AN ADAPTIVE REUSE PROPOSAL FOR THE FORMER BERRIMA GAOL

**Western Hotel Rooms
Between the Escarpment and the Wall**
Clarification of the design rationale and visual impact of proposed hotel suites

Item 3. Western Hotel Rooms

Hotel Suites presented at SDRP1 - Sorgenfrei Arrangement

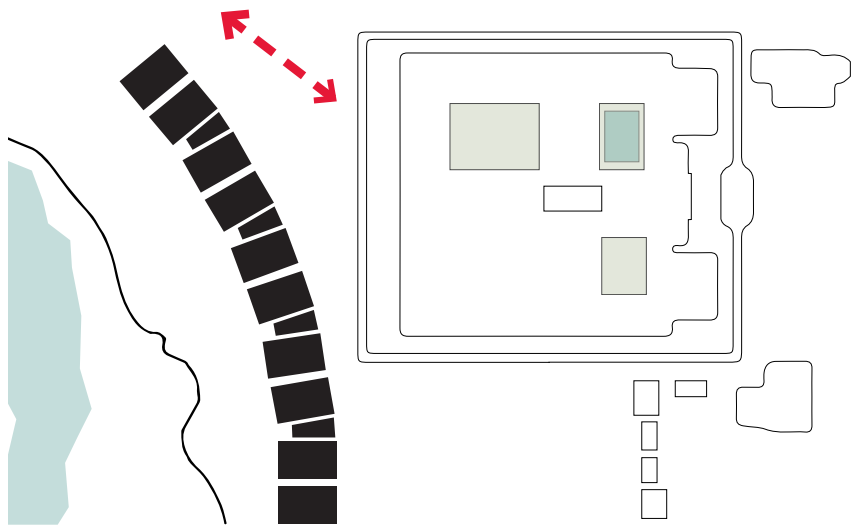
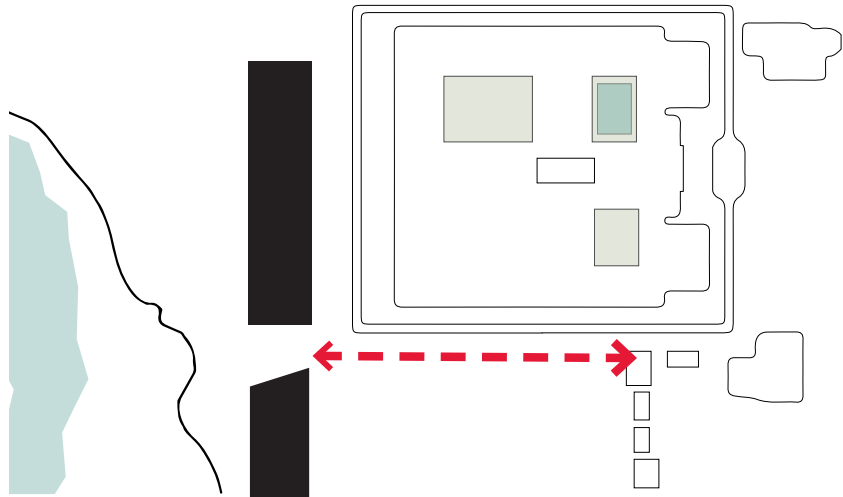
SDRP No.1 Comment Item 8.
The strong axial nature of the existing building should guide the placement and design approach of new buildings.

SDRP No.1 Comment Item 10a.
suit the scale of the surrounding context, noting that the gaol is currently the largest spatial presence in town

SDRP No.2 Comment Item 10b.
Allow framing and highlighting of views from the gaol to the river and from the opposite bank to the Gaol Wall

SDRP encouraged a stronger geometric relationship with the gaol wall and greater clarity between historic and contemporary elements.

In response to SDRP 1, the design team moved away from the dispersed Sorgenfrei arrangement and adopted a more geometric relationship with the gaol wall.

Hotel Suites presented at SDRP2 - Bar Form Arrangement

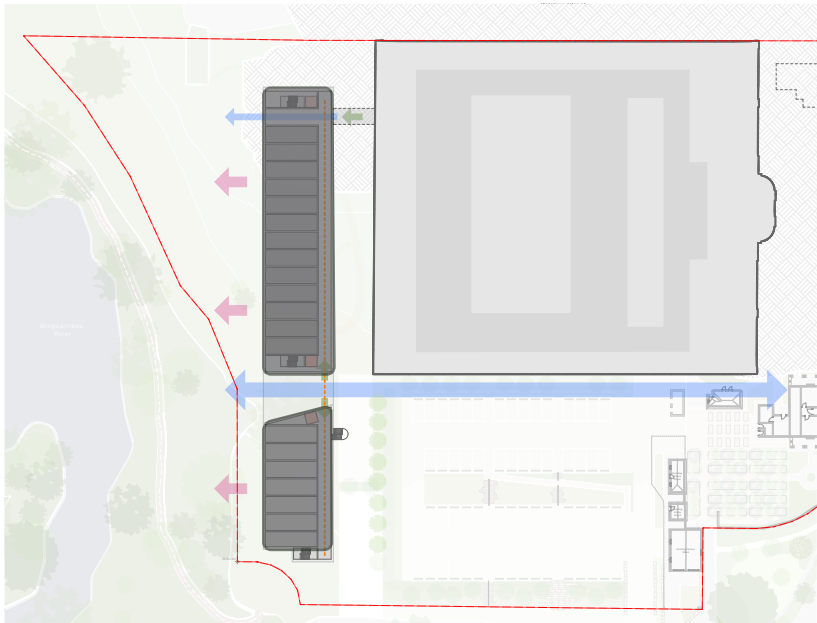
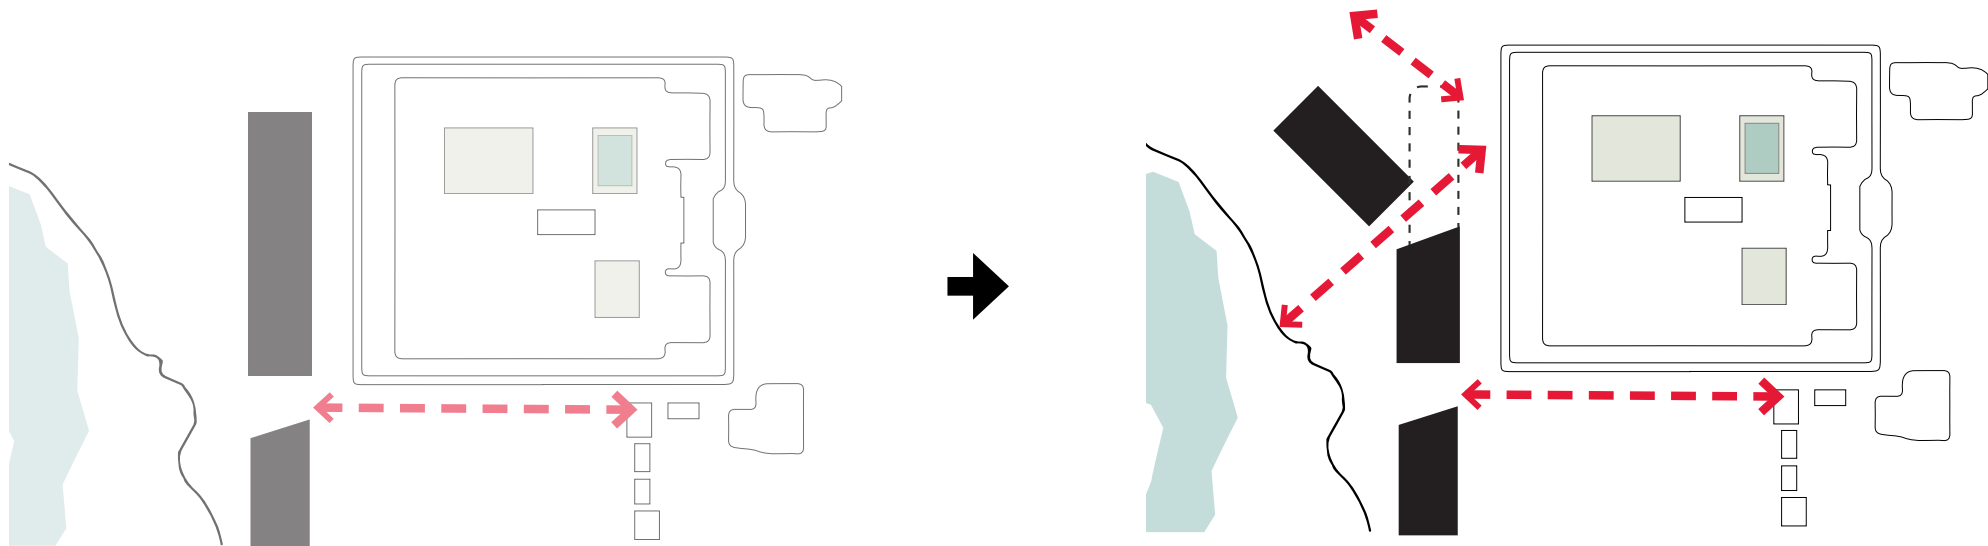
SDRP No.2 Comment Item 10. Reduce visual bulk and scale. Increase upper level setback, provide additional articulation and views between hotel suites

SDRP No.2 Comment Item 11. Interrogate opportunities for stepping the ‘Bar’ so there is greater distance between hotel suites and Gaol Wall.

Reduce the visual bulk and scale

Increase the articulation and permeability between the suites

Improve the relationship with the landscape

Test stepping and separation to reveal more of the gaol wall

'Bar Form' massing, which was the preferred choice by the SDRP Panel, was refined further in response to feedback, with stepped forms that enhance the spatial buffer around the 'Secret Door,' strengthen key view corridors to the gaol wall and Governor's Residence, and introduce deeper upper-level setbacks.

- Increased Articulation
- Increased Setbacks
- Increased View Corridors
- Increased Landscape Separation
- Retained hotel yield & operability streams

Figure 5. Key additional viewpoints
Source: Nearmap and Colliers Urban Planning

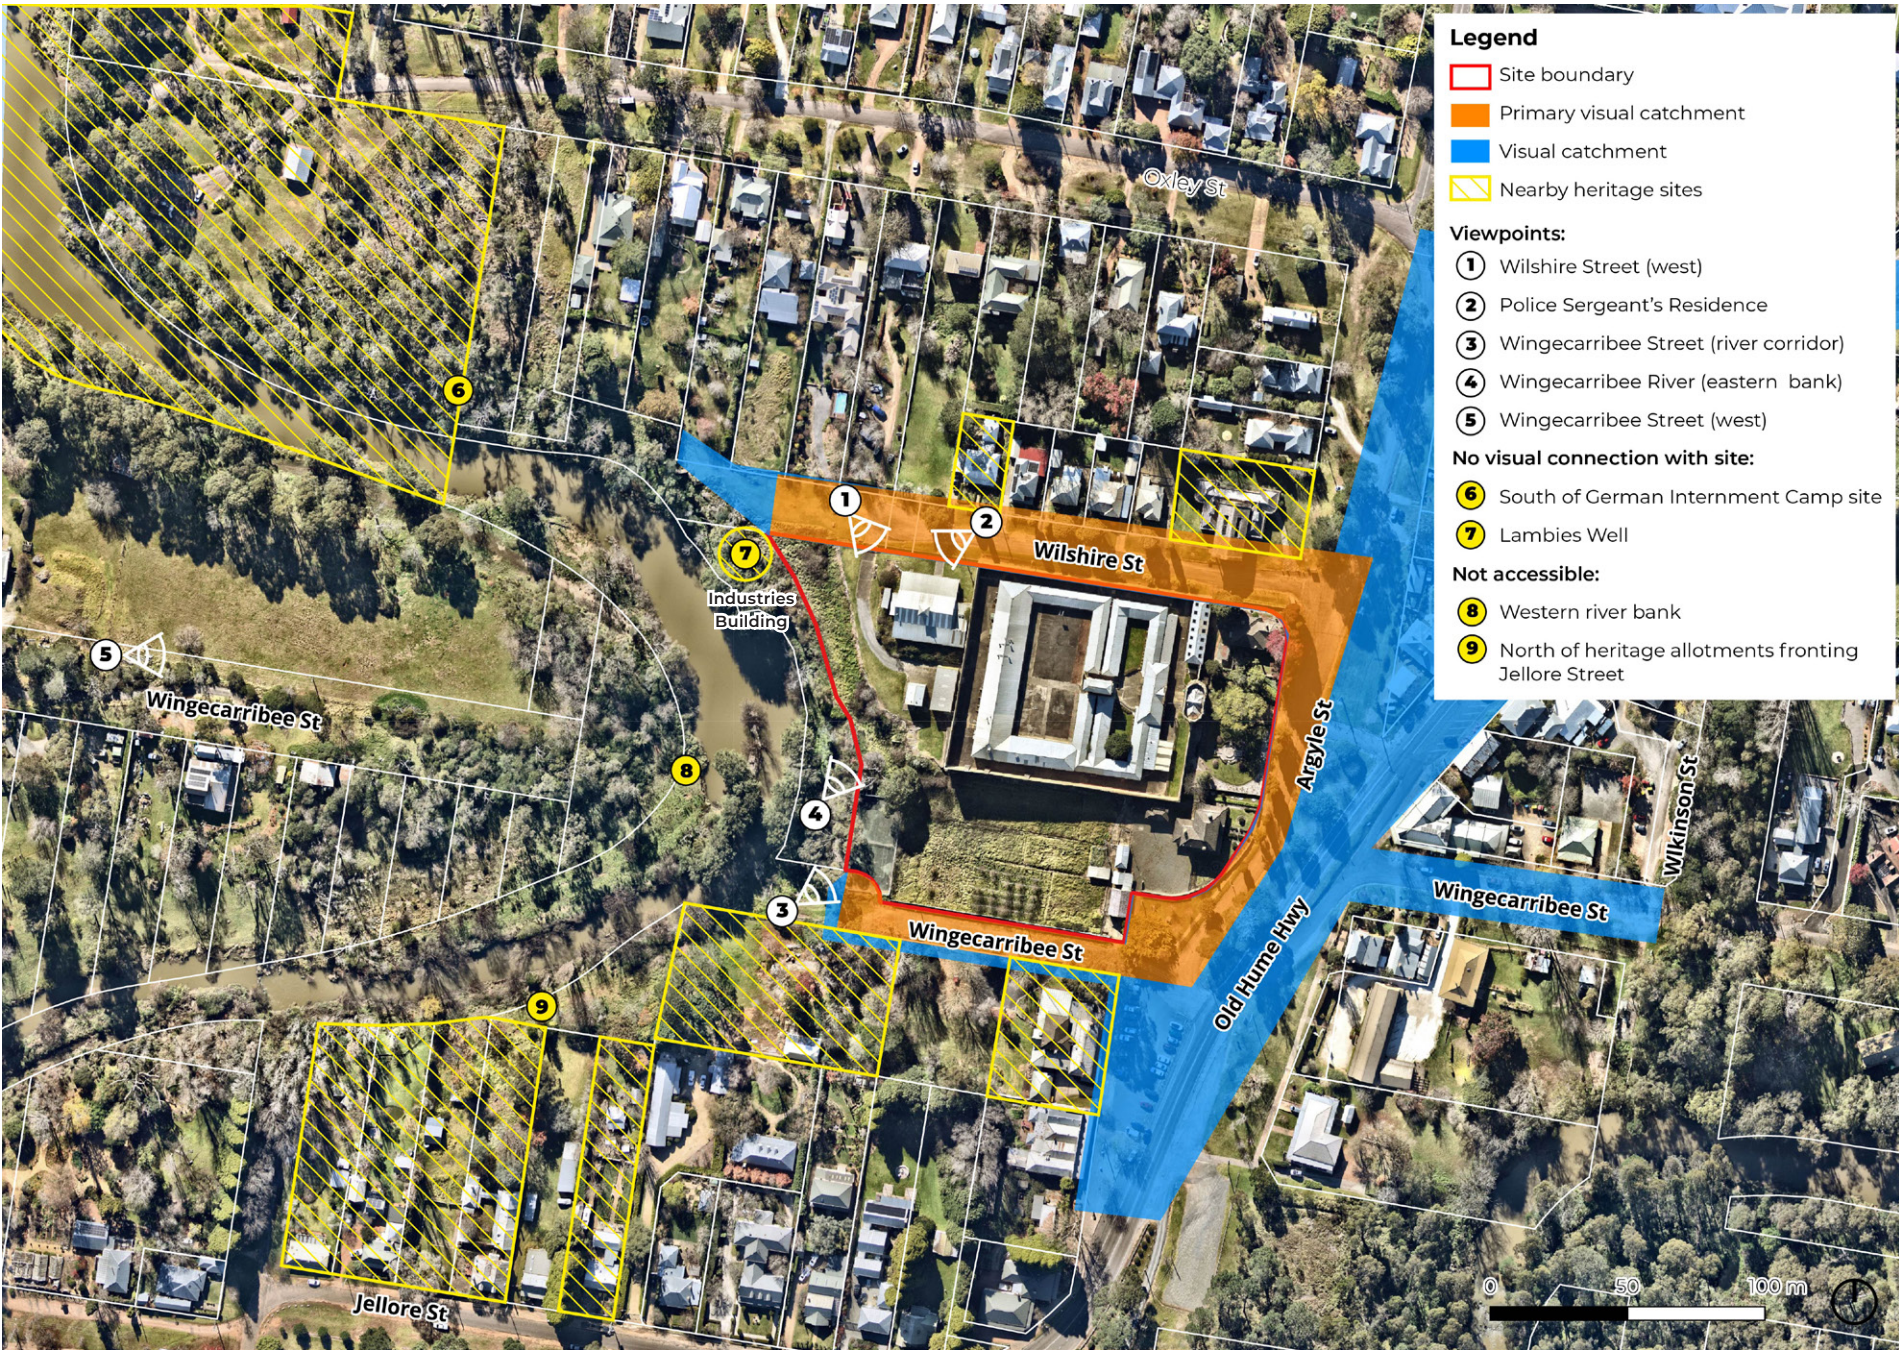
The department and the Heritage Council have specifically requested additional assessment of four vantage points associated with the Western Hotel Suites -

- Views from Wingecarribee River looking east,
- Western end of Wilshire Street looking south onto western hotel rooms and west onto the escarpment,
- Views along Wingecarribee Street looking north onto the western hotel suites

“The additional viewpoint analysis undertaken in response to the Department’s request confirms that whilst the proposed western hotel suites represents a change to the visual conditions of the site, the proposal has been assessed as **having an acceptable visual impact**. Furthermore, the proposal’s architectural and landscape expression is considered to **overall improve the visual quality of the site and its context.**”
